Nomad

SERVICE BULLETIN

RE-ALIGNMENT HORIZONTAL STABILISER CONTROL PULLEY (MOD N63)

Figure 1 Alignment Tool - Replacement strut pick-up fittings

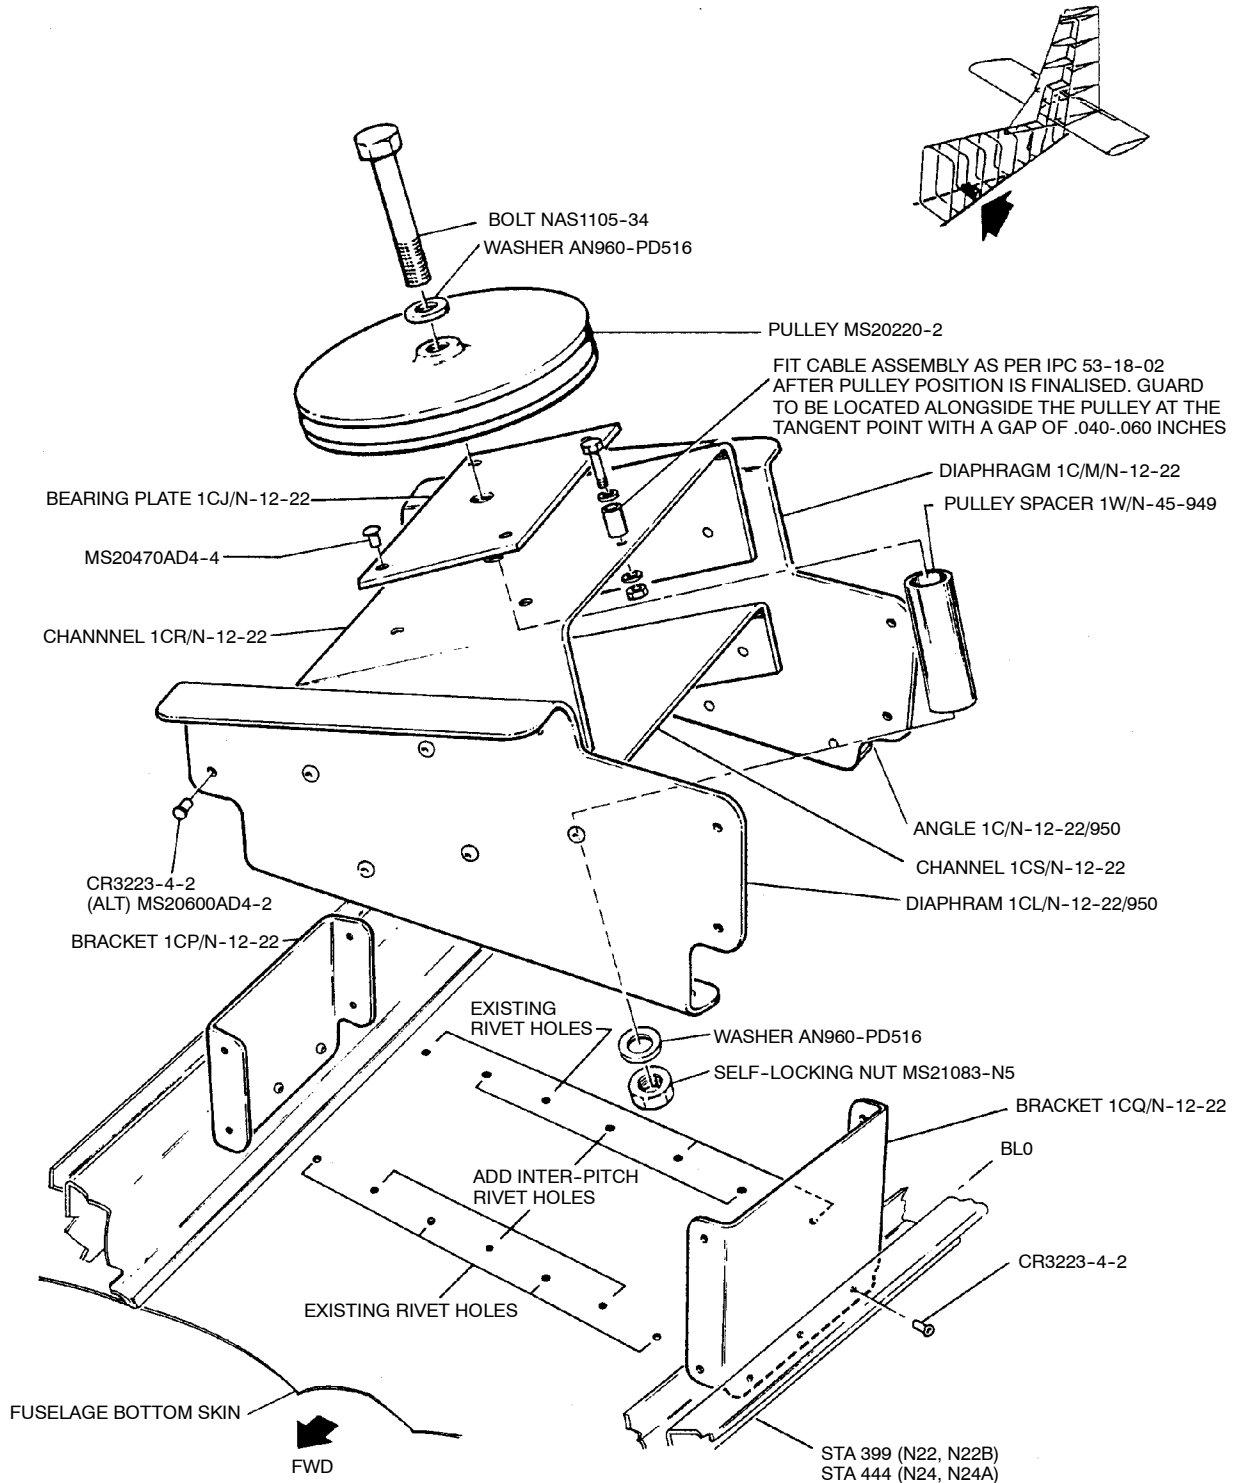
The pulley mounting bracket at Sta 399 (N22), Sta 444 (N24), is removed and replaced with similar bracket to obtain correct cable/pulley alignment.

- (1) Remove the pulley from its mounting bracket (Ref MM Chap 27-40-03). Retain the pulley, and the attaching washers and self-locking nut (Ref IPC Chap 53-18-02 Figure 1 items 23, 24 and 25). Discard the pulley mounting bolt and spacer (Ref IPC Chap 53-18-02 Figure 1 items 26 and 27).
- (2) Remove and retain the cable guard bolt, washers and self-locking nut (Refer IPC Chap 53-18-02 Figure 1 items 31, 30, 28 and 29 respectively) from the pulley mounting bracket.
- (3) Remove the pulley mounting bracketry from the rear fuselage and remove the bearing plate Part No. 1CJ/N-12-22 (Ref Figure 1) from the bracket.

- (4) Install new pulley mounting bracketry (Ref Figure 1)
 - (a) Plug with solid rivets the four rivet holes marked A (Ref Figure 1) in the fuselage bottom skin.
 - (b) Rivet brackets PN 1CP/N-12-22 and 1CQ/N-12-22 to the fuselage structure picking up existing rivet holes. Oversize rivets (Ref Para 3.C. may be used if rivet holes have been damaged when removing the original bracketry.
 - (c) Rivet diaphragm PN 1CL/N-12-22/950 to the outer faces of the forward flanges of the brackets installed at step (b) and to the fuselage bottom skin using existing rivet holes. Oversize rivets (Ref Para 3.A.) may be used if rivet holes have been damaged when removing the original bracketry.
 - (d) Rivet channels PN 1CS/N-12-22 and 1CR/N-12-22 to the diaphragm installed at step (c).

- (7) Rivet the bearing plate PN KJ/N-12-22 to the upper channel PN 1CR/N-12-22. (Ref Figure 1)
- (8) Assemble the pulley and attaching parts to the new mounting bracket as shown in Figure 1.

- (10) Ensure that the cable is correctly routed around the pulleys then locate and fit the cable guard bolt, washers and self-locking nut (removed at step (2)) as per Figure 1.
- (11) Check the rigging of the horizontal stabiliser, including full and free movement and break-out checks (Refer MM Chap 27-40-00).

Figure 2 Alignment Tool - Replacement strut pick-up fittings

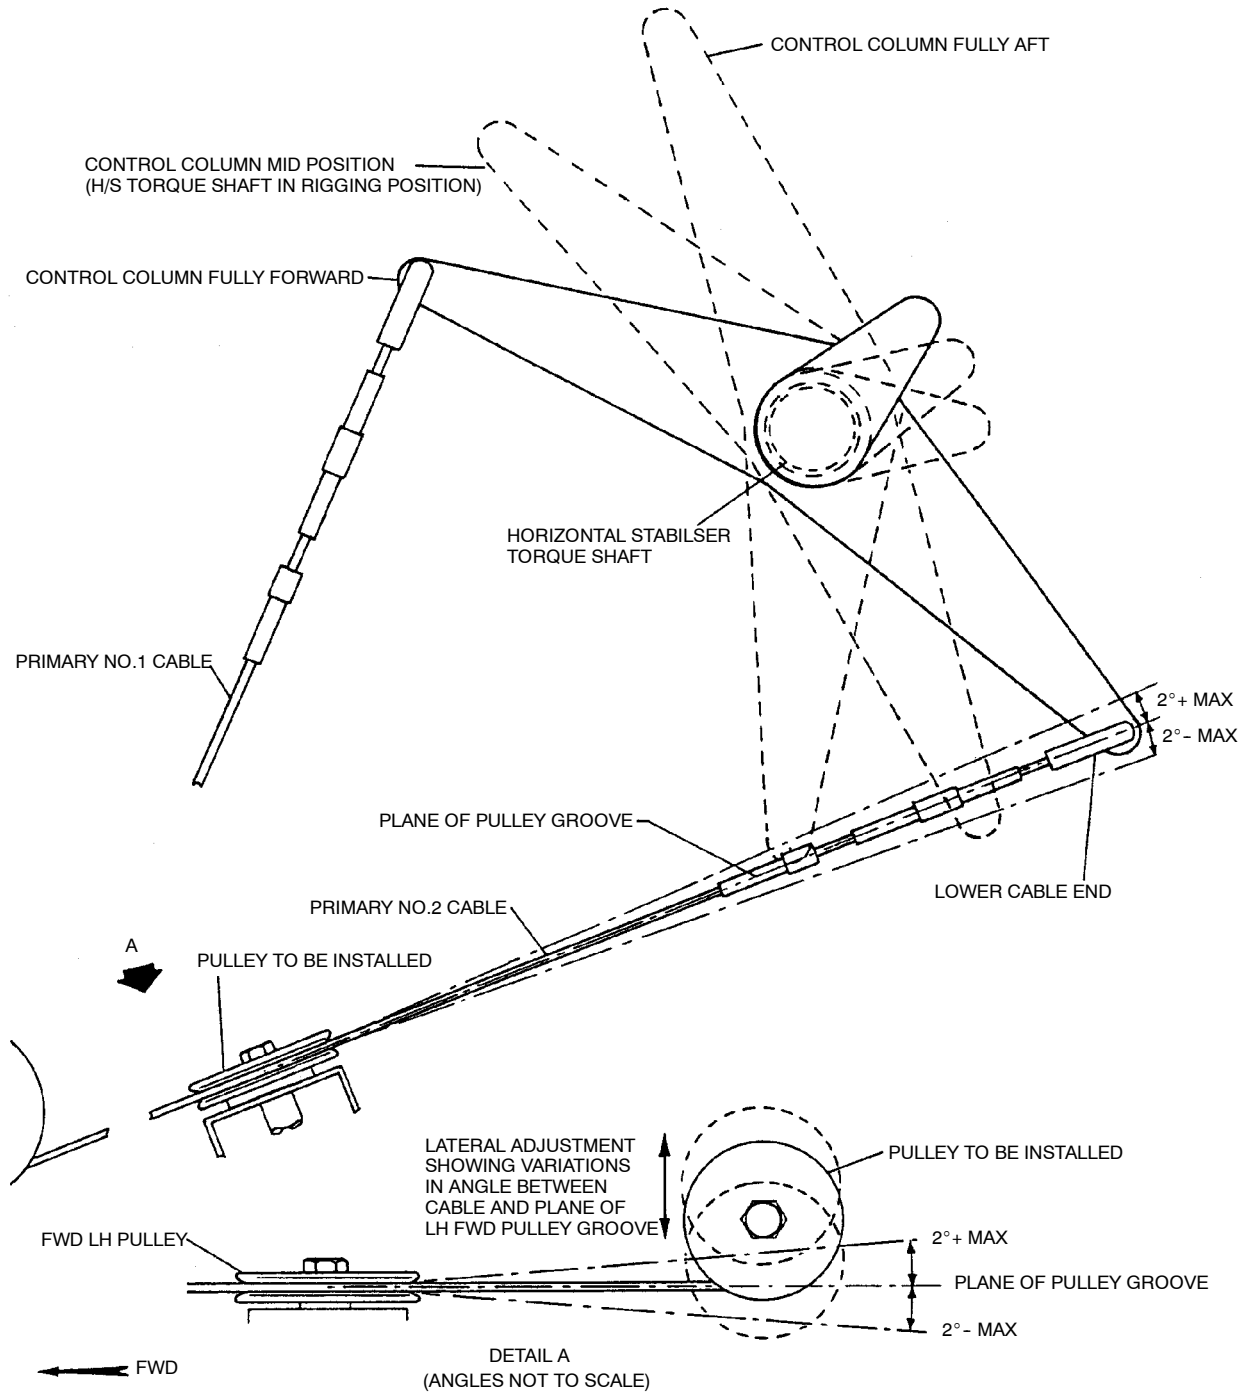
- (h) Rivet the angle to the fuselage bottom skin and the diaphragm installed at step (e).
- (5) The optimum position of the pulley to be installed (Ref Figure 2) is that which reduces to a minimum the angle of the control cable (+ 2 degrees Max) to the plane of the pulley's groove and also the angle of the control cable to the plane of the groove of the LH pulley (viewed looking forward) of the two pulleys located forward and adjacent to the newly installed bracketry. To determine the optimum position of the pulley to be installed, carry out the following procedure.

- (c) Assemble the pulley to be installed on top of the bearing plate and maintain the assembly together using bolt PN NAS1105-34.
 - (d) Position the pulley and bearing plate assembly on top of the newly installed bracketry, so that with the string touching the bottom of the pulley groove, the angle between the string and the plane of the forward LH pulley groove is at a minimum (+ 2 degrees Max).

- (f) Maintaining the position of the pulley and bearing plate assembly (established in step (d)), check that the angle between the string and the plane of the pulley groove does not exceed + 2 degrees throughout the range of travel of the torque shaft. If necessary, adjust the position of the pulley and bearing plate assembly to reduce the angle to within + 2 degrees and at the same time ensuring that the angle of the string to the plane of the forward LH pulley groove also does not exceed + 2 degrees.
